CENTRAL Registry (120-5-18-9) S G Building Construction - Working Project - General Assembly & North parking (1/22) - 1 Nov 1951
Fuller-Turner-Walsh-Slatery Inc.

FULLER - TURNER - WALSH - SLATTERY, INC.
UNITED NATIONS CONTRACT
403 EAST 42ND STREET
NEW YORK 17, N. Y.

Re: Contract HQ 1/82 - General Assembly and North Half Parking Space
CHANGE NO. 330 - Revision to North Column Ducts

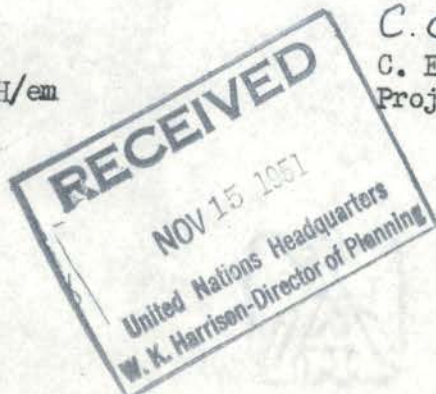
Although approved by you on October 22, 1951, this drawing
has been revised to show four (4) $\frac{1}{4}$ " Plate Stiffeners welded
to the $\frac{1}{4}$ " Bent Plate (in head of Upper & Lower Booth Bays)
in each Bay of 7 degrees and 30 minutes.

This revision is in accordance with your Mr. Roy Nelson's
request and is being submitted for record purposes.

TYPICAL MUNTIN ASSEMBLY

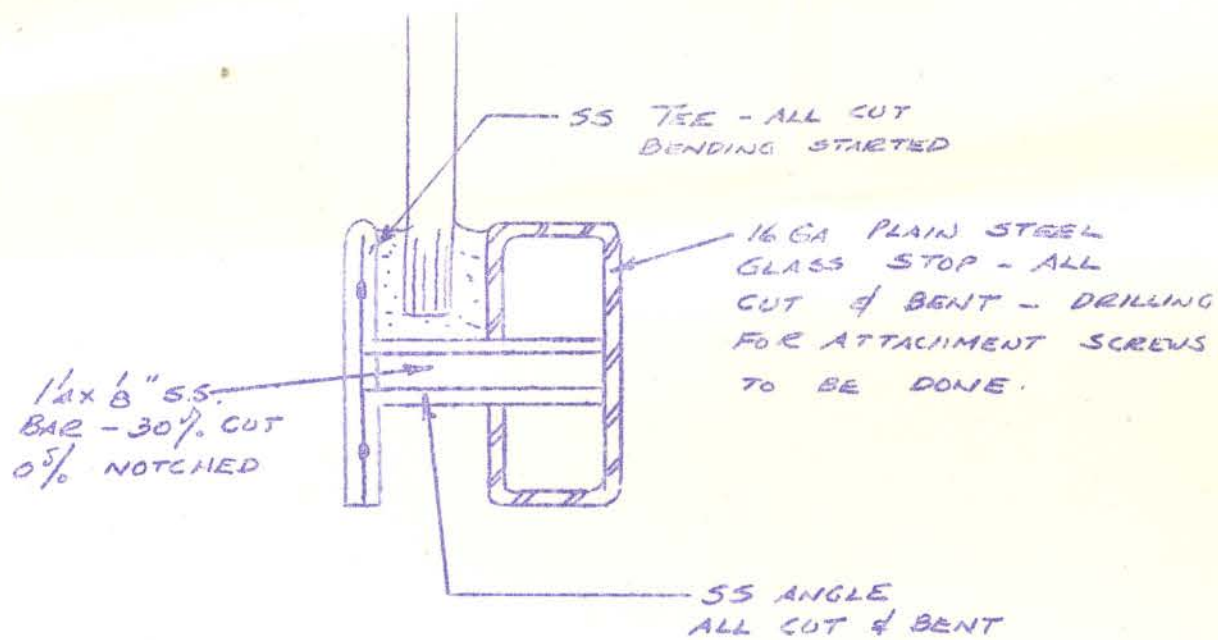
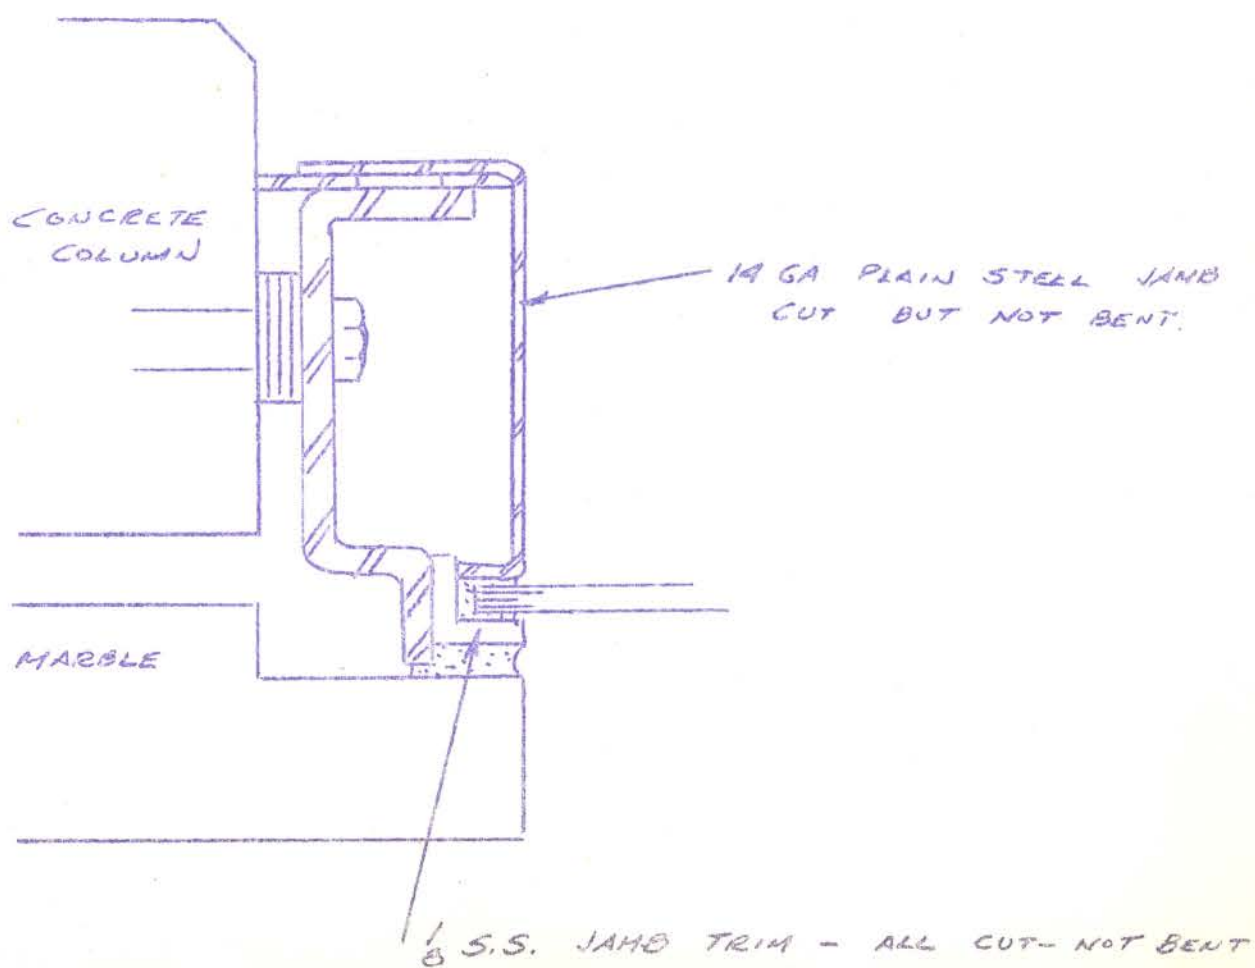
re: Inspection Report 1/82 - General Bronze Corp.

2 HGP-97-1 2 Aug'51 Supports for Railings

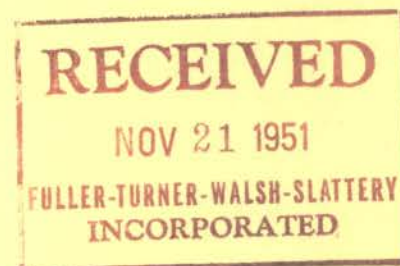
Drawing HGP-97-1 was previously approved by you on 9/7/51. Since then several dimensional errors have become apparent and a copy of the approved drawing was marked-up by your Mr. Van Riper, with a request for resubmittal of the present corrected drawing.
